# Building TB-21-633

Responses to building permit review comments  
Addendum #2-3

**ANGLERS FOUR HUNDRED  
 DETAILED GRADING  
 & DRAINAGE PLAN (WEST)**

SHEET  
**C.301**  
 OF 28 SHEETS

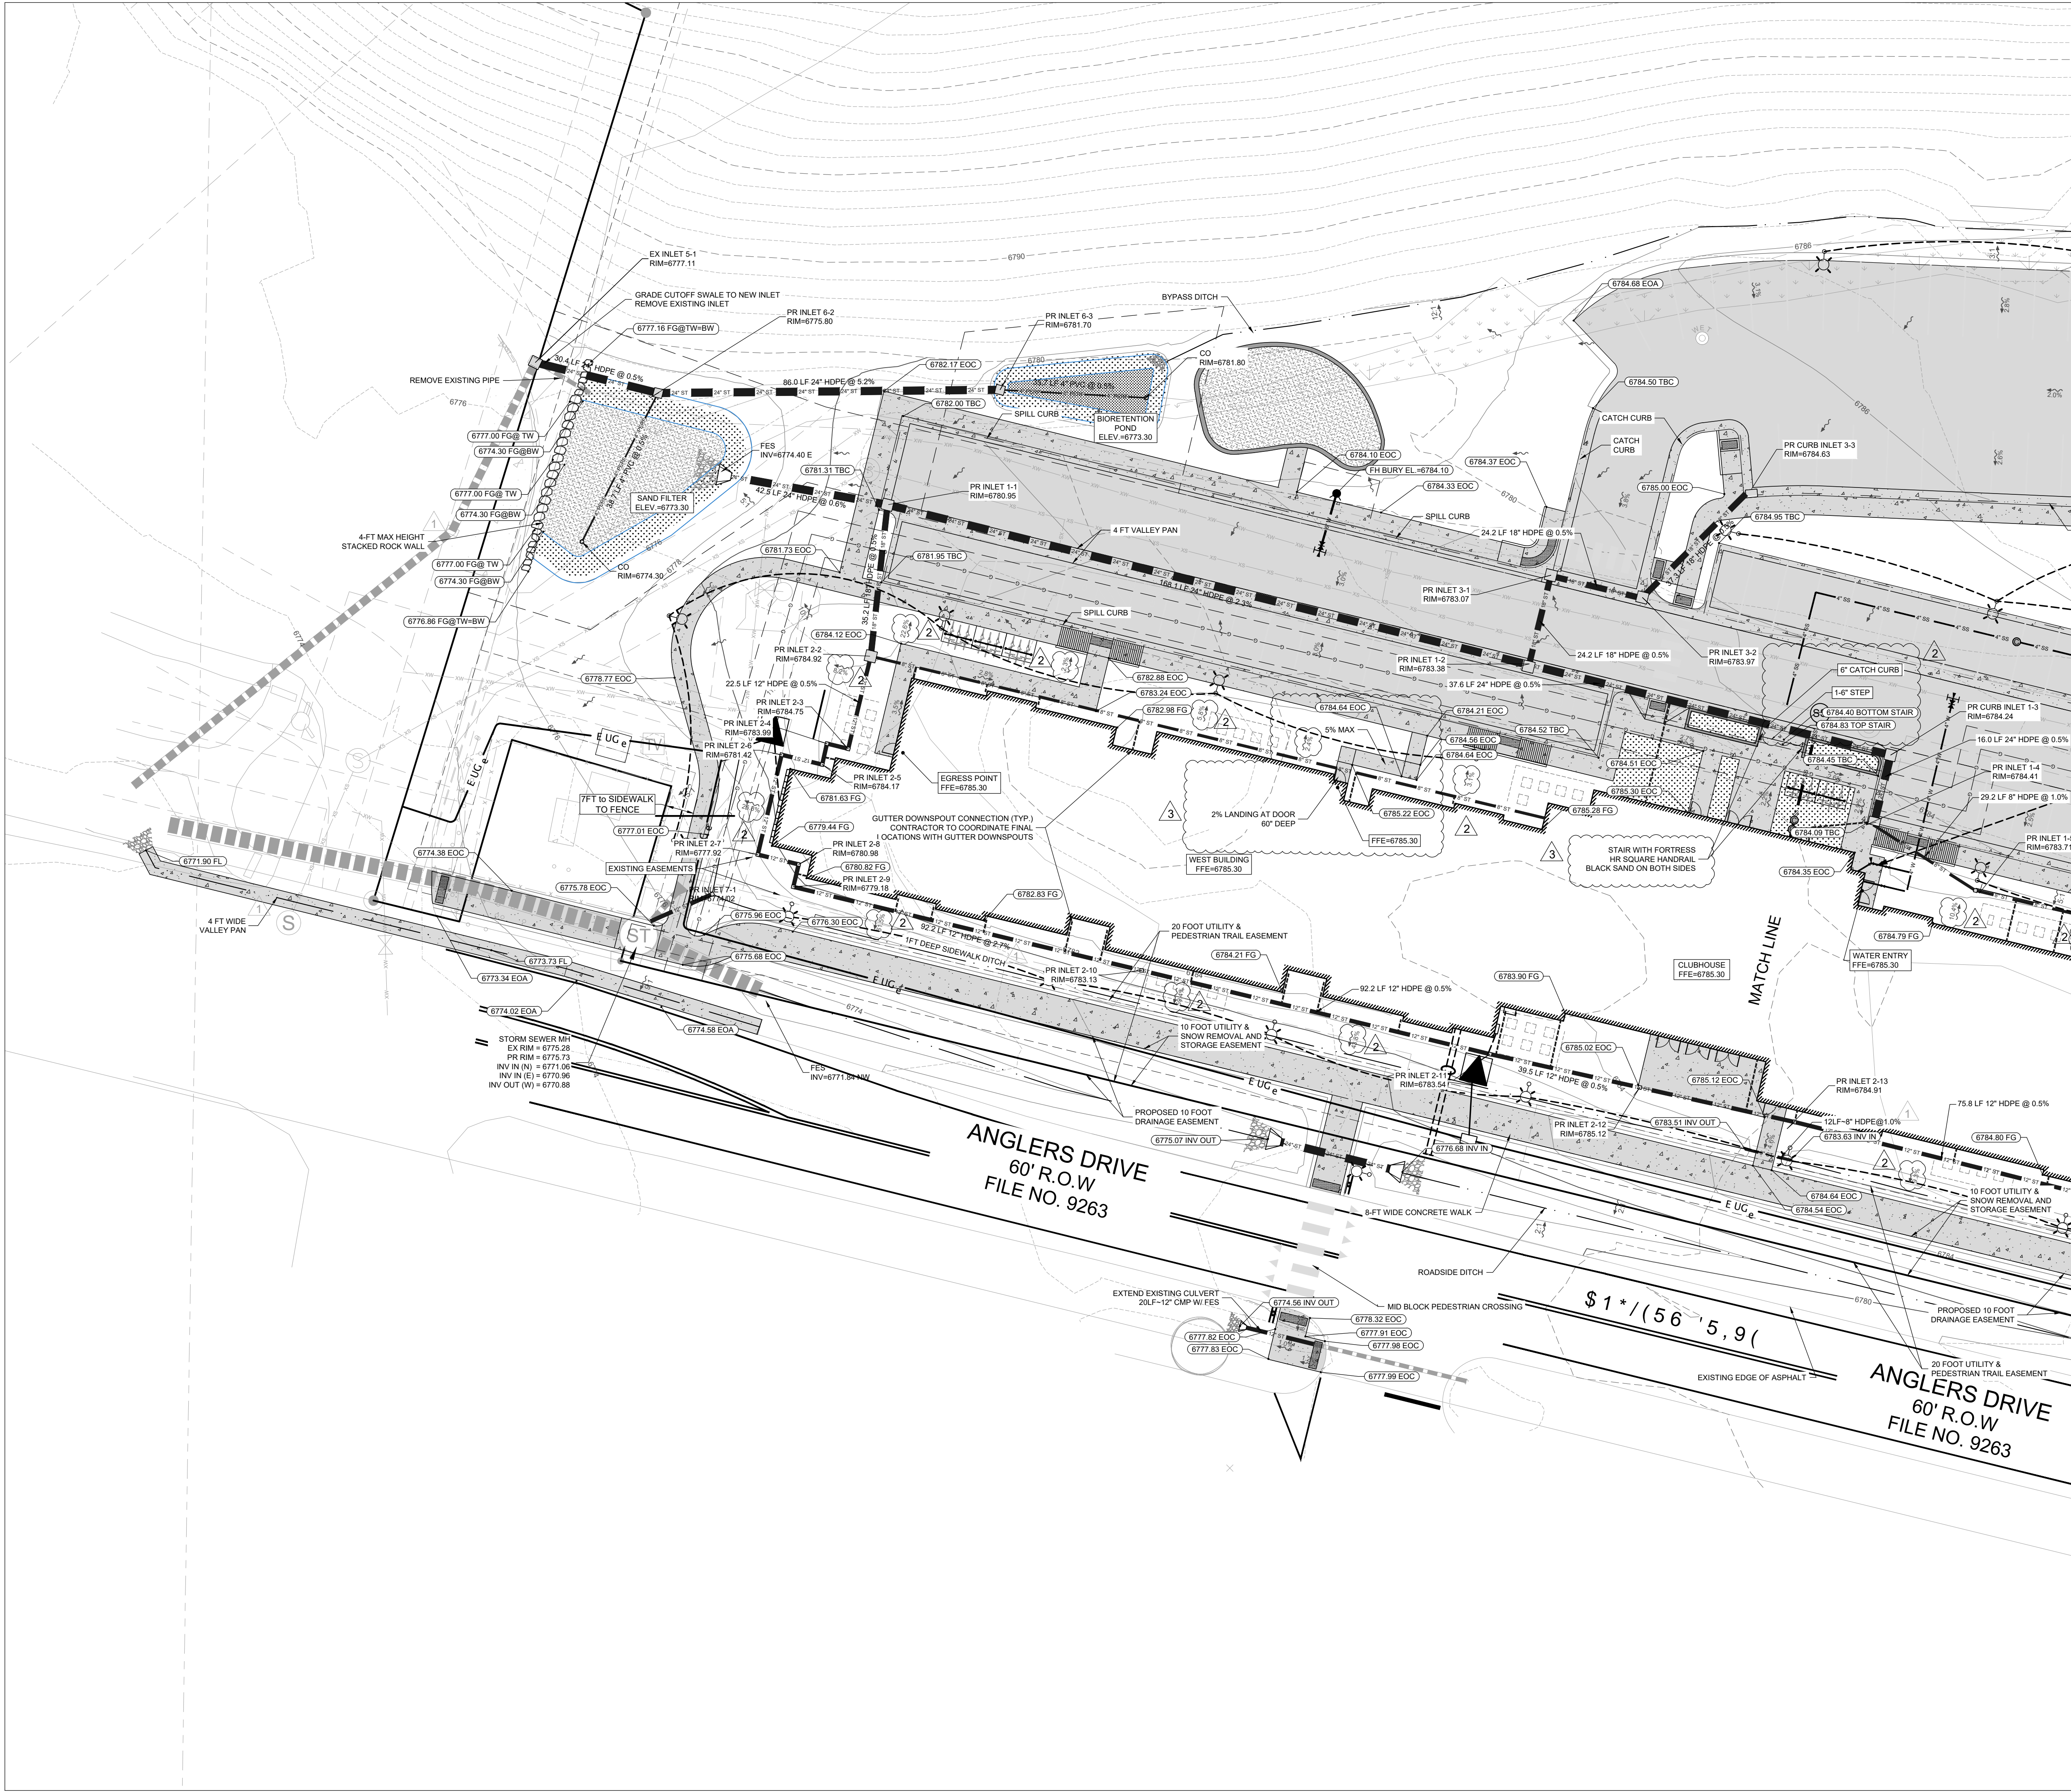
15. The door #132 as shown on comments per building review, is a fire sprinkler closet, not an egress door. A ramp with adjusted slope is now shown on C3.01 with adequate length for ADA and railings with landings per code, if necessary.
